Corrigendum No. -03 Date:- 26.07.2021

Subject of the NIT:- OPEN TENDER ENQUIRY FOR "TENDER SPECIFIC STRATEGIC TIE-UP FOR "CONSTRUCTION OF 400 KV AND 220 KV TRANSMISSION LINE WORK (DETAILS AS BELOW) INCLUDING SUPPLY OF ALL EQUIPMENT/MATERIALS, ERECTION (INCLUDING CIVIL WORKS), ARRANGEMENT / SETTLEMENT OF RIGHT OF WAY, TESTING & COMMISSIONING ON EPC BASIS" FOR M/S RRPVNL AT PACHPADRA IN RAJASTHAN.

PRE BID CLARIFICATION

Sub :- Construction of 400/220KV GSS Pachpadra along with 500MVA 400/220/33 KV Transformer and 400 KV, 125MVAR Bus Reactor Including Supply of All Equipments/Materials, Erection (Including Civil Works), Testing and Commissioning (on Turnkey Basis) and associated 400KV & 220KV Transmission Lines Under Bid No.: BN-9019002102, (UBN- VPN2122WLOB00193).

FOR TENDER PURPOSE ONLY
400 KV SIDE SECTION LAYOUT OF .

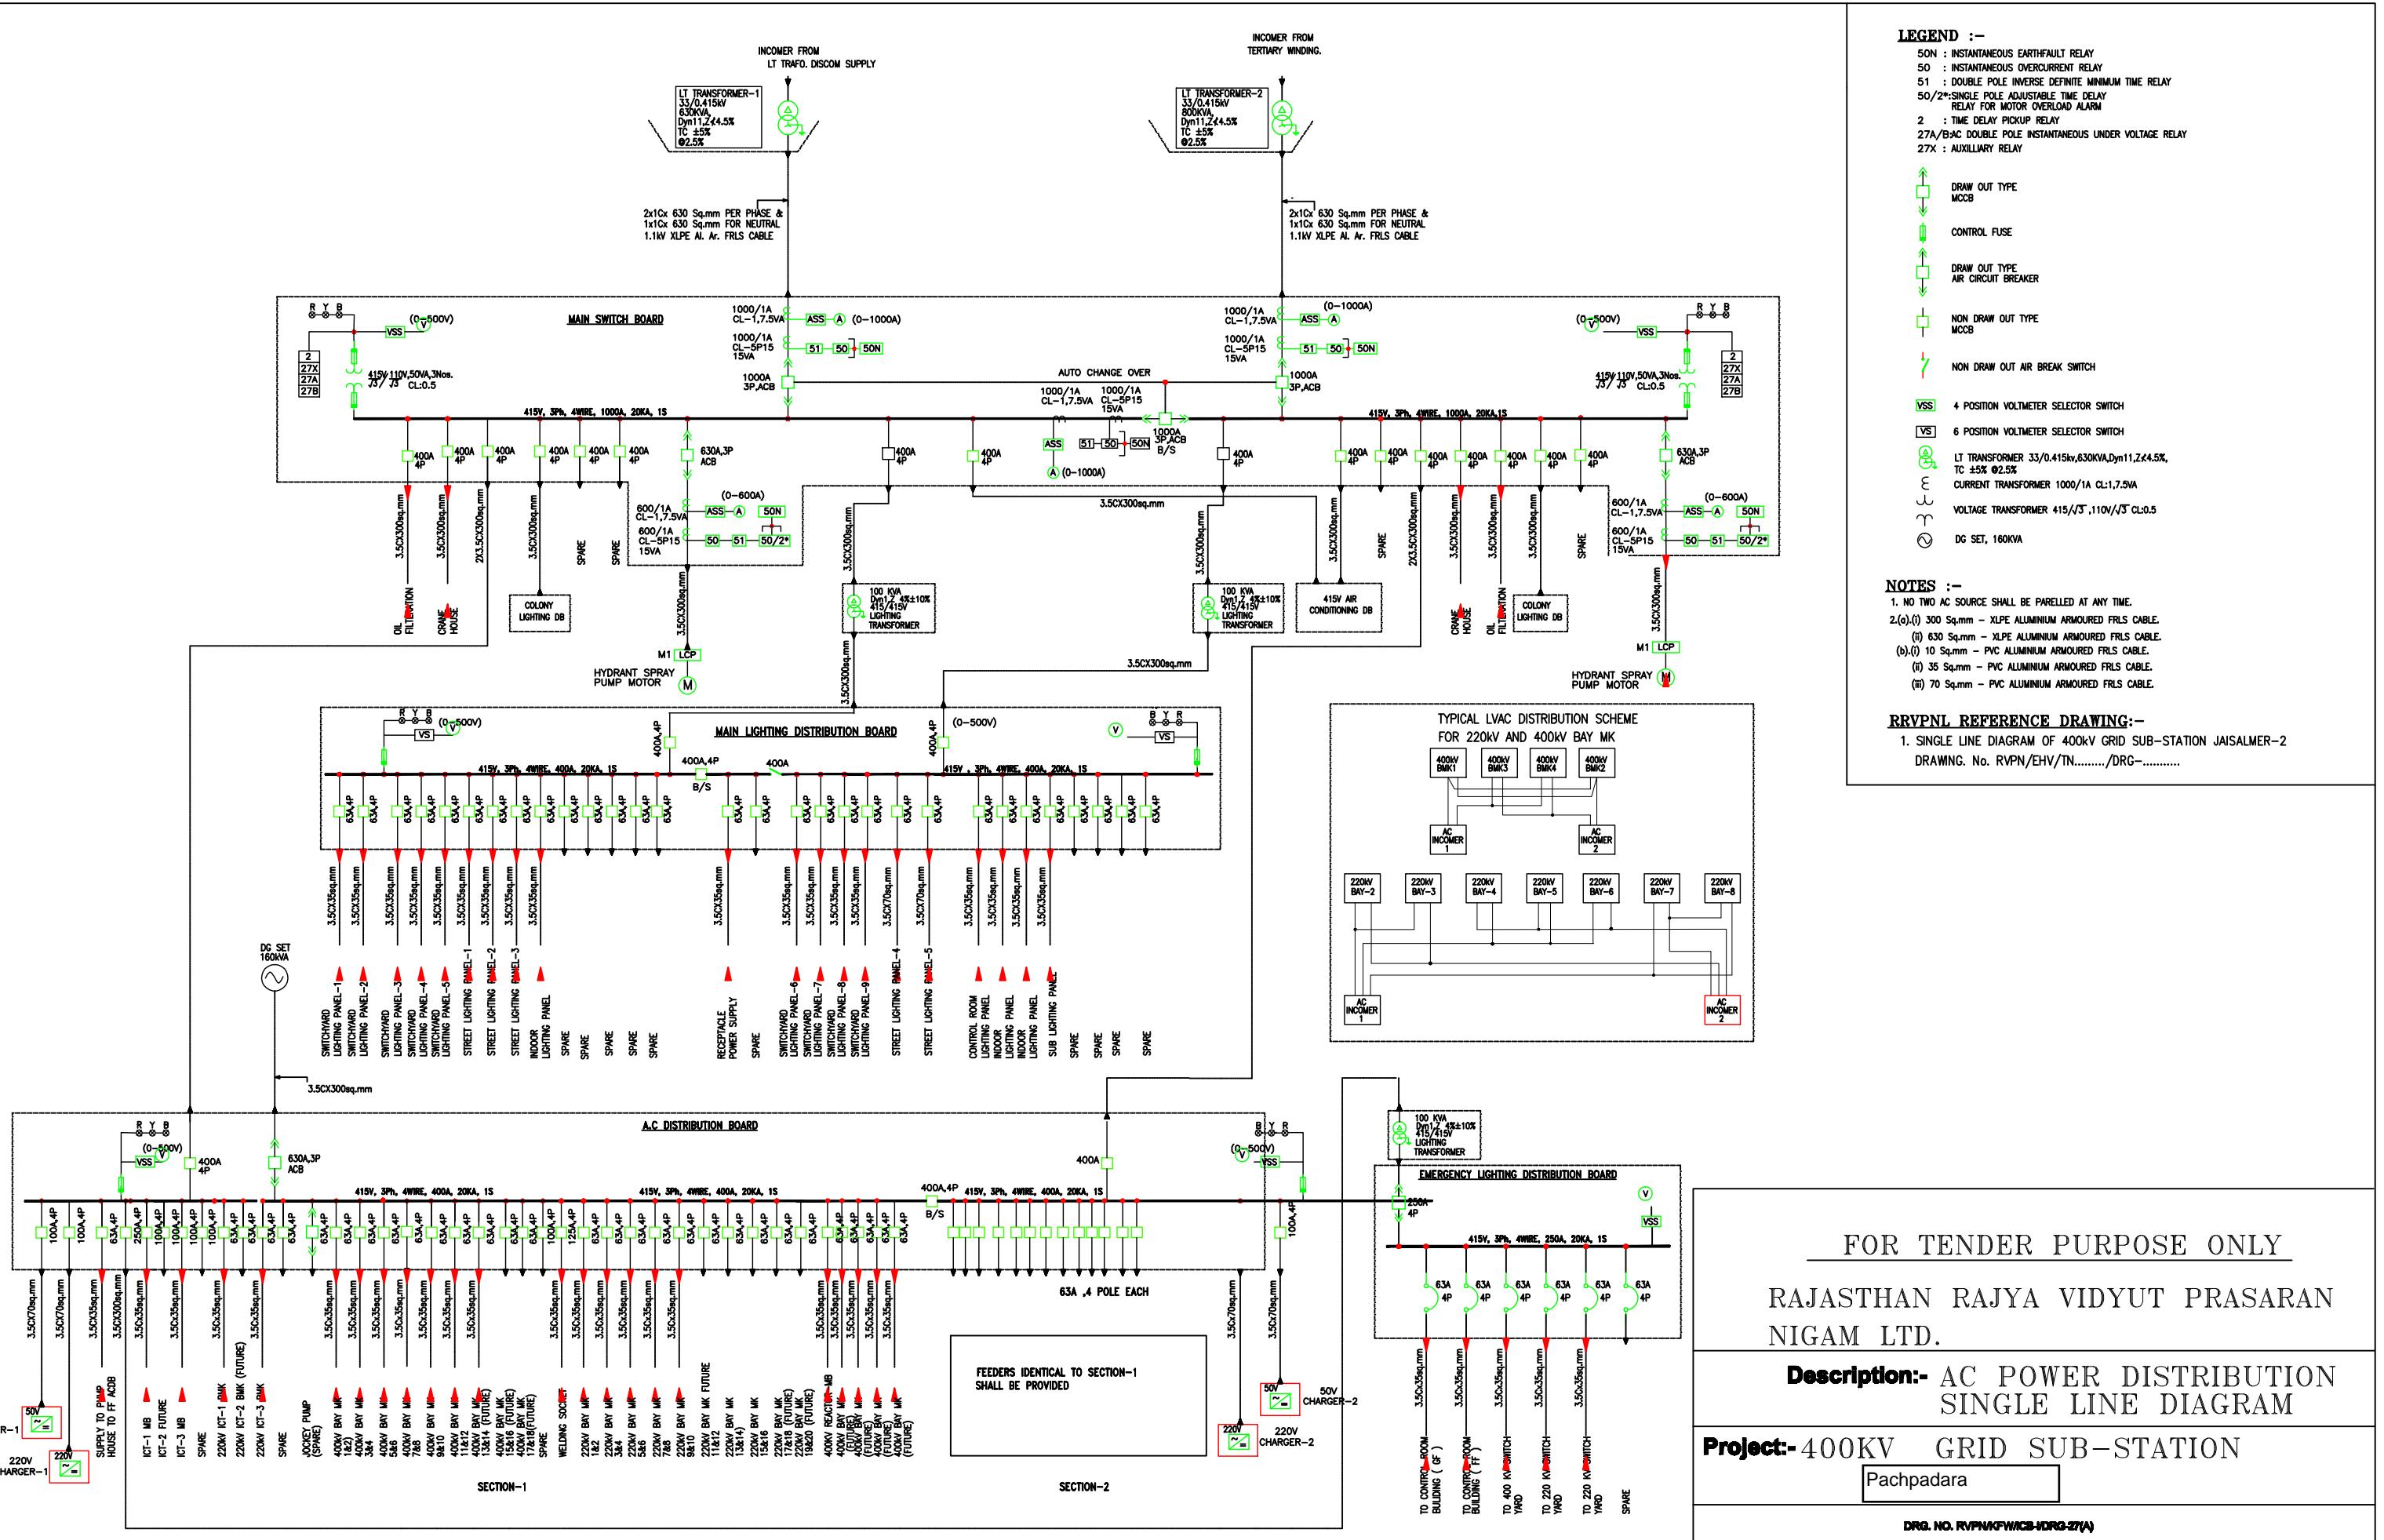
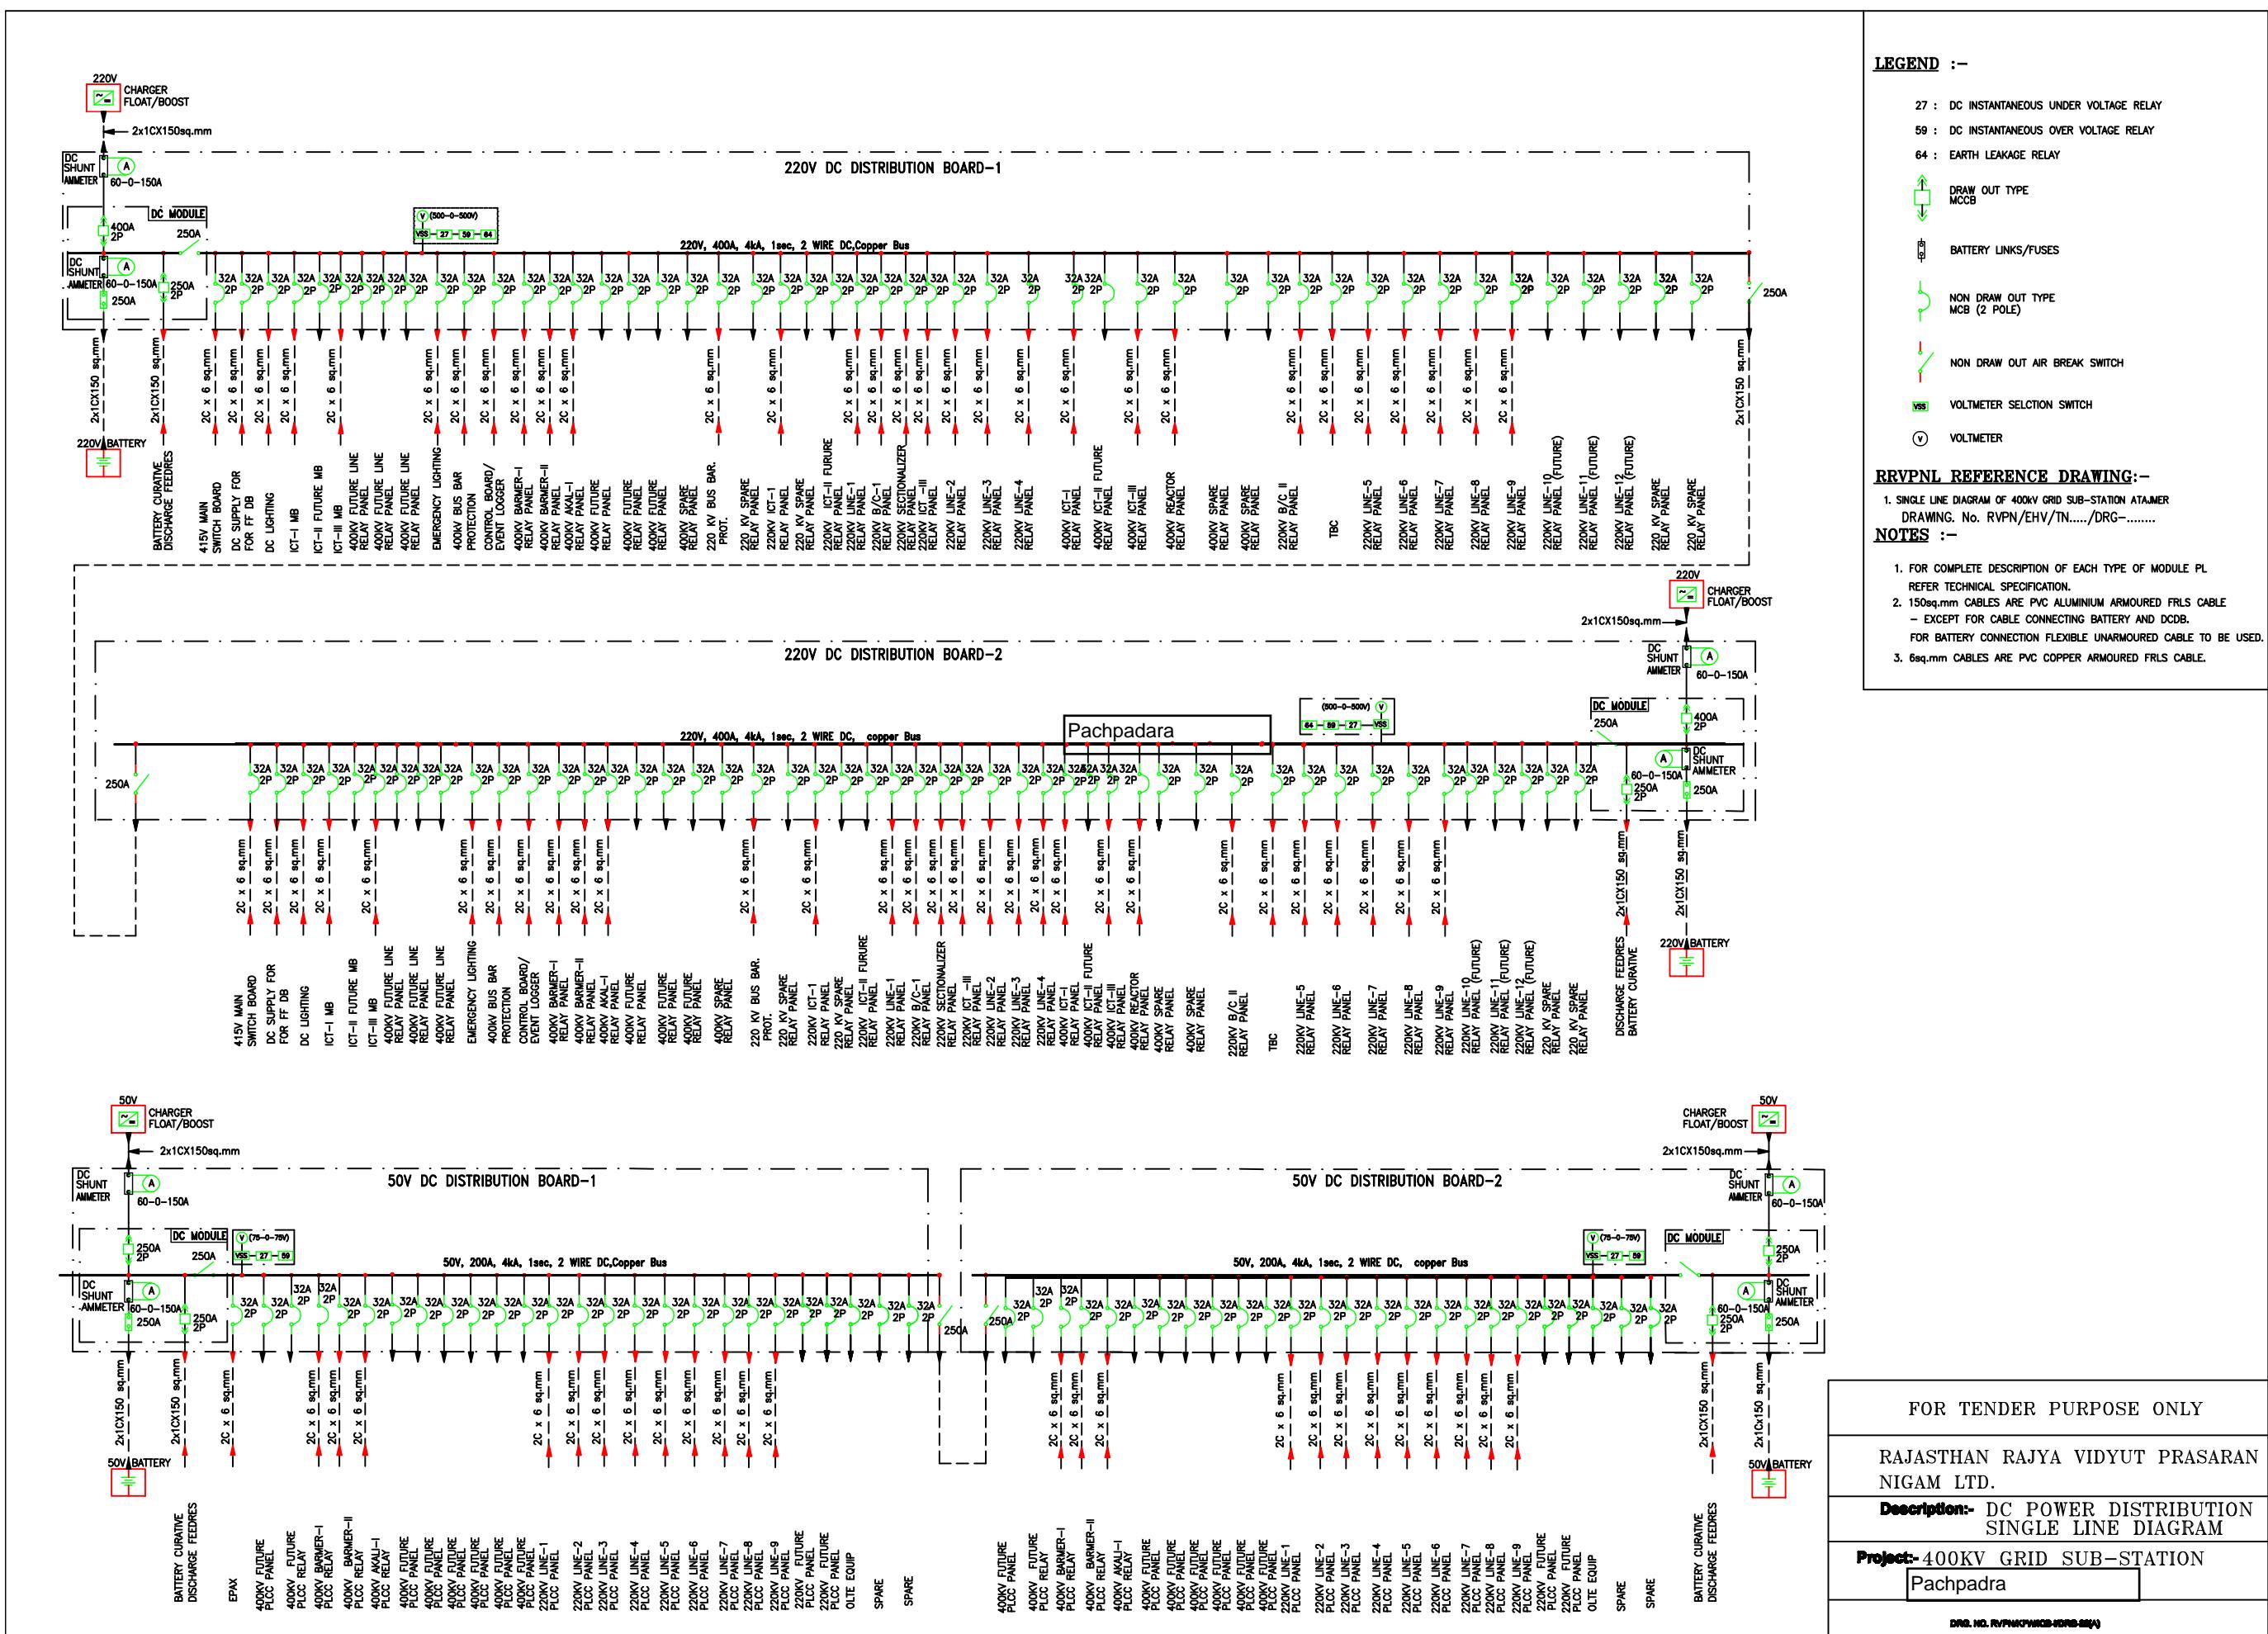
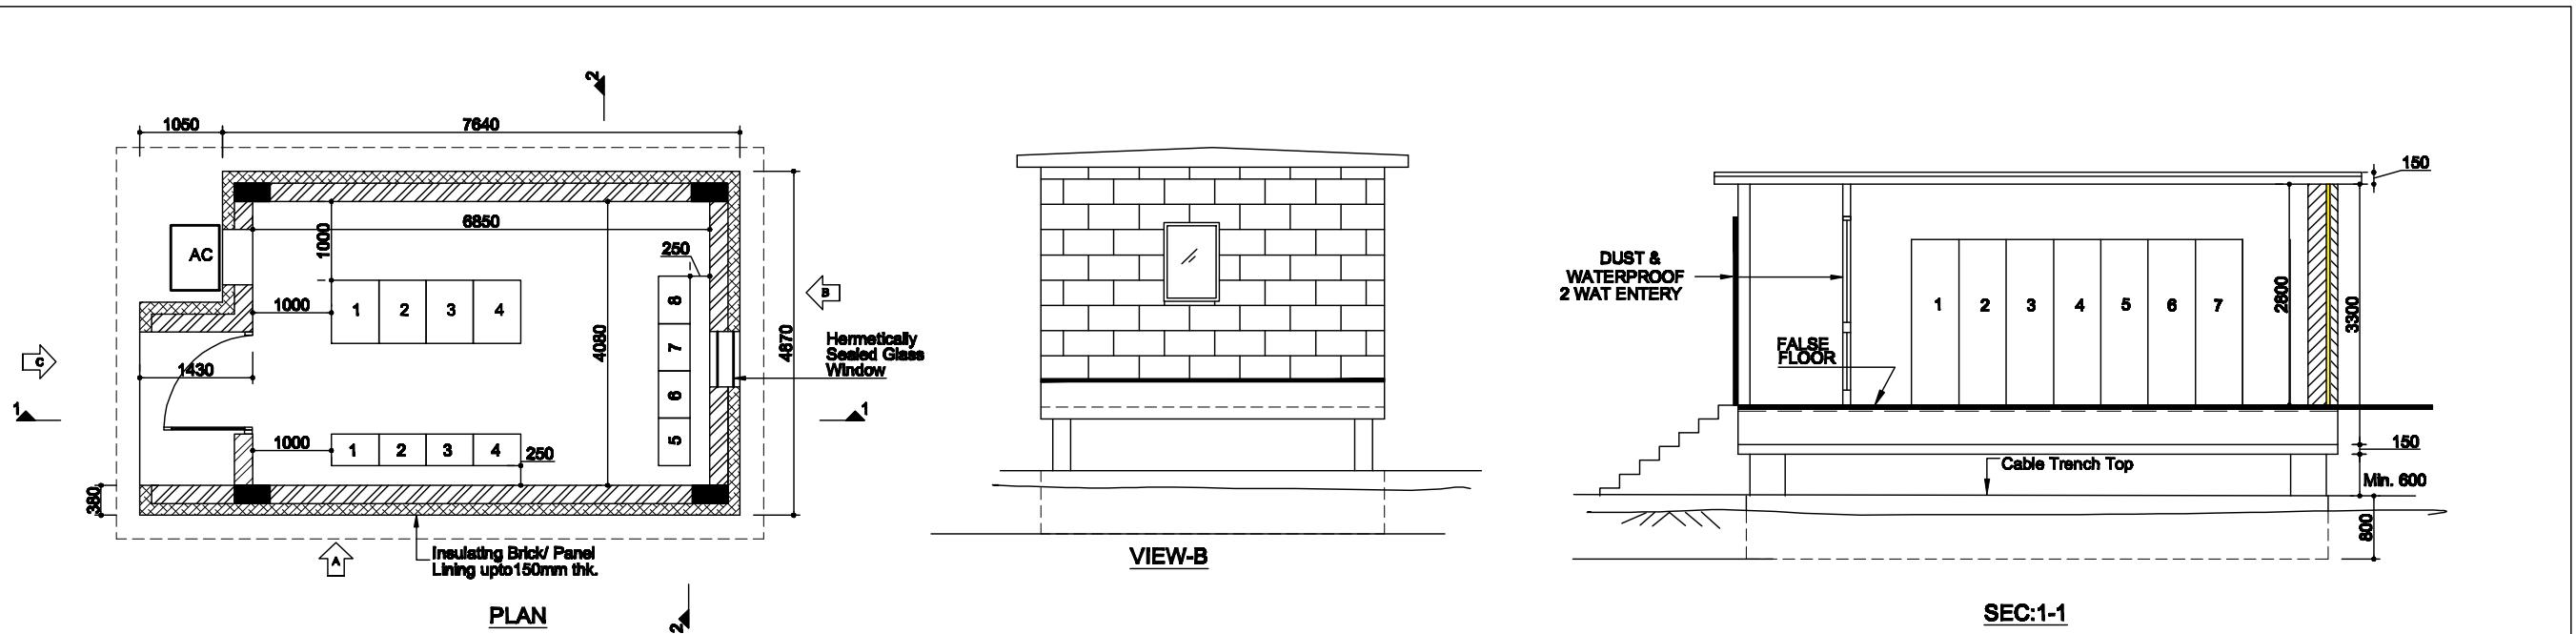
3	Drawings	400/220KV GSS PachpadraSLD	In given tender document there is no SLD attached in "Drawings " It is requested to provide the 400/220KV GSS Pachpadra- SLD for better understanding.	SLD Enclosed.
4	Drawings	400/220KV GSS- Section Layout	<p>In BPS some of the line items are estimate (i.e Insulator hardware, BPI's ,Insulators ,Clamps etc) by BIDDER however given "400/220KV GSS" Section's is not clear for understanding the design .It is requested to furnish the clear PDF /CAD drawing for better to estimate the LOT items.</p> <p>In given tender document there is no SECTION LAYOUT for 220KV in "Drawings " It is requested to furnish the clear PDF /CAD drawing for better to estimate the LOT items.</p>	<p>Section drawing for 400 KV & 220 KV Enclosed.(for tender purpose only)</p>
